SUBJECT: Forwards preliminary design info for ATWS sys scheduled for
 installation during 1989 refueling outage, per commitment.
 Final design phase in progress. Detailed answers to NRC
 860922 questions will be provided in Apr 1988.

Subject: Anticipated Transients Without Scram
R.E. Ginna Nuclear Power Plant
Docket No. 50-244

KEY ELEMENTS - R.E. GINNA ATWS SYSTEM

FIGURE #1

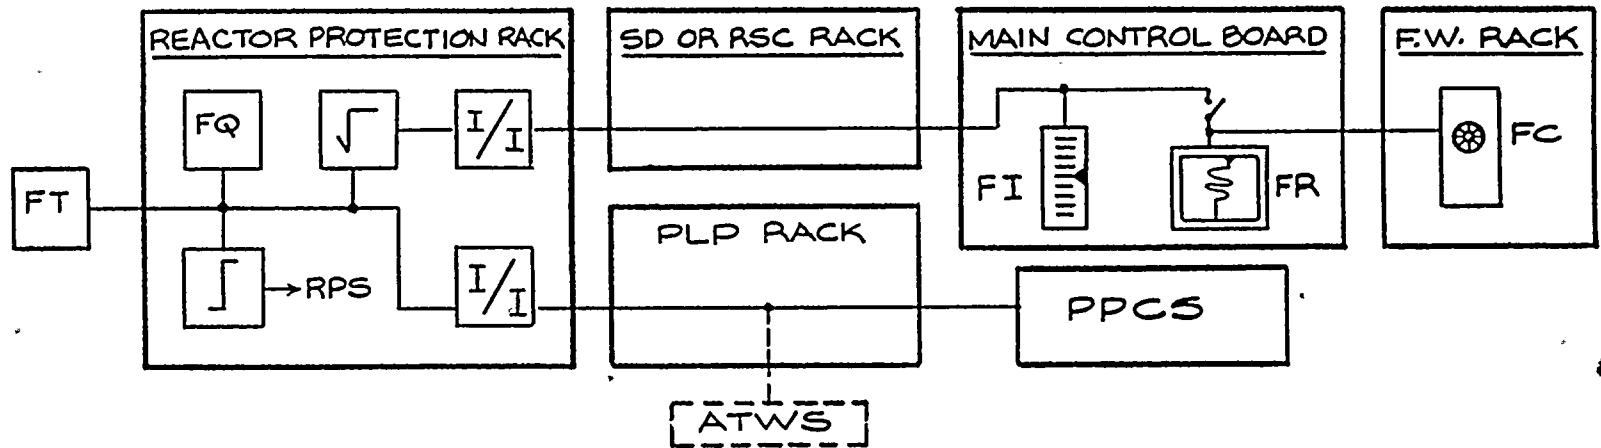
The plant specific submittal should indicate the degree of diversity that exists between the AMSAC equipment and the existing Reactor Protection System. Equipment diversity to the extent reasonable and practicable to minimize the potential for common cause failures is required from the sensors output to, but not including, the final actuation device, e.g., existing circuit breakers may be used for the auxiliary feedwater initiation. The sensors need not be of a diverse design or manufacture. Existing protection system instrument-sensing lines, sensors, and sensor power supplies may be used. Sensor and instrument sensing lines should be selected such that adverse interactions with existing control systems are avoided.

The tentative RG&E design utilizes Feedwater Low Flow to sense and respond to an ATWS event. Figure 1 illustrates how the ATWS system inputs are to be obtained from the existing feedwater flow instrumentation. For diversity, the new ATWS hardware will be other than Foxboro H Line (Consotrol) and Westinghouse BF relays.
